DART SERVICE INSTRUCTION

TO AMEND INSTALLATION INSTRUCTIONS IIN-D205-778 REV. B
AND INSTRUCTIONS FOR CONTINUED AIRWORTHINESS ICA-D205-778 REV. 1

To provide instructions to allow the hook strip (ie. velcro) on the D3752-1 Seat Frame to be fastened with rivets.

FIGURE 1: RIVET INSTALLATION
 (CUSHIONS NOT SHOWN)

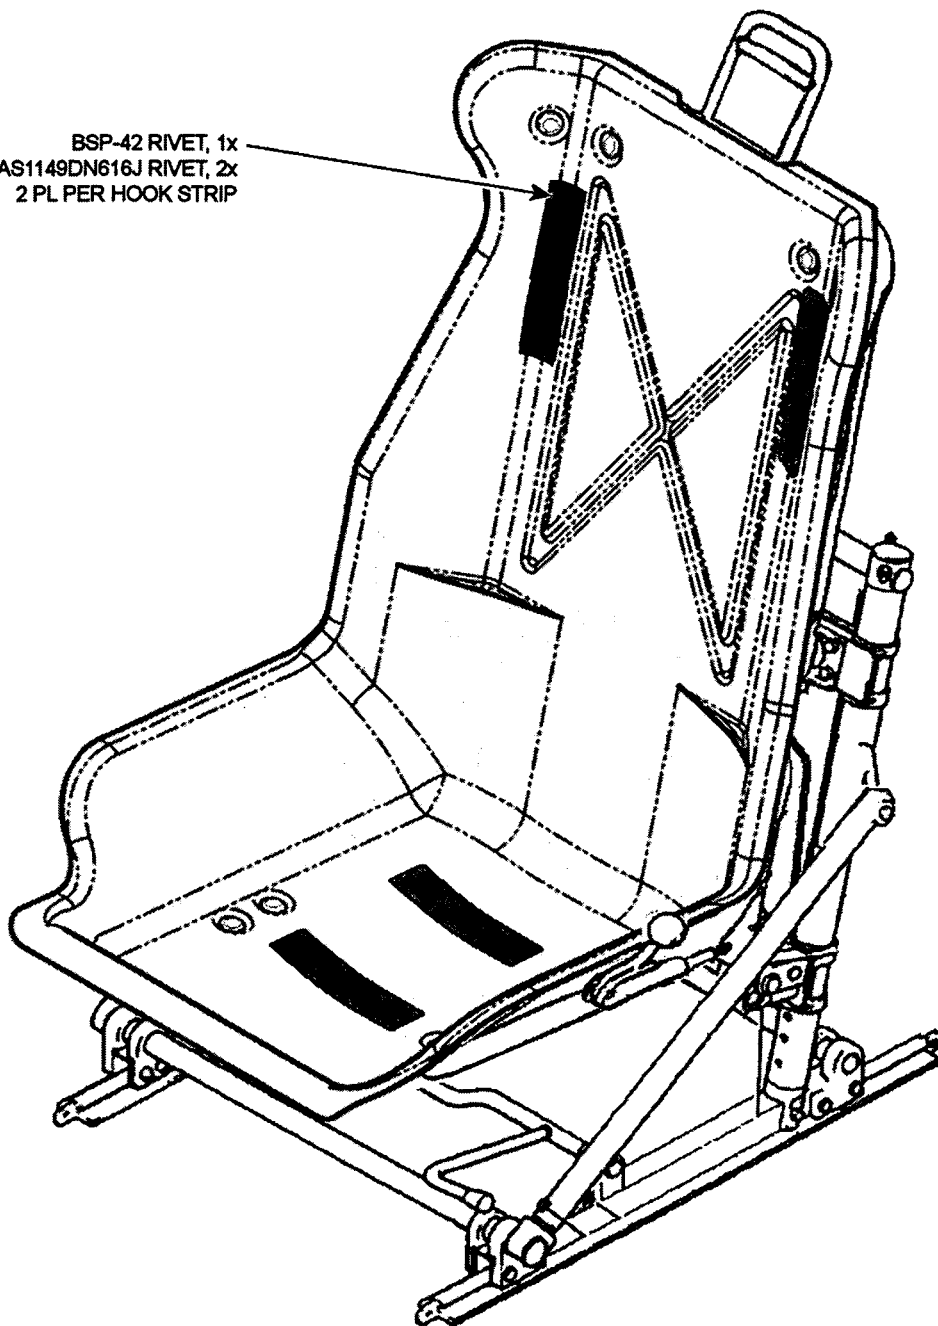
D205-778-011 Comfort Seat Kits at CHG 002 have rivets and washers that may be installed to fully secure the D3800-3-200-060 Hook Strip to the D3752-1 Seat Frame. The parts list of Installation Instructions IIN-D205-778 and Instructions for Continued Airworthiness ICA-D205-778 is amended as shown below. Installation of the rivets is optional.

Install the BSP-42 rivets as detailed below, see Figure 1 of this service instruction as reference:

- 1) Ensure location of D3800-3-200-060 Hook Strip lines up with loop strip on seat cushions.
- 2) Drill D3752-1 Seat Frame using 9/64" (Ø0.141) drill in appropriate locations: ensure rivet location will not interfere (contact) with the OEM metal seat frame. Deburr hole.
- 3) Install each BSP-42 rivet with qty(2) NAS1149DN616J washers (one on either side of the plastic seat frame). It is acceptable to substitute longer/shorter BSP rivets or thicker NAS1149DN632J washers to ensure proper fit.

BSP-42 RIVET, 1x
 NAS1149DN616J RIVET, 2x
 2 PL PER HOOK STRIP
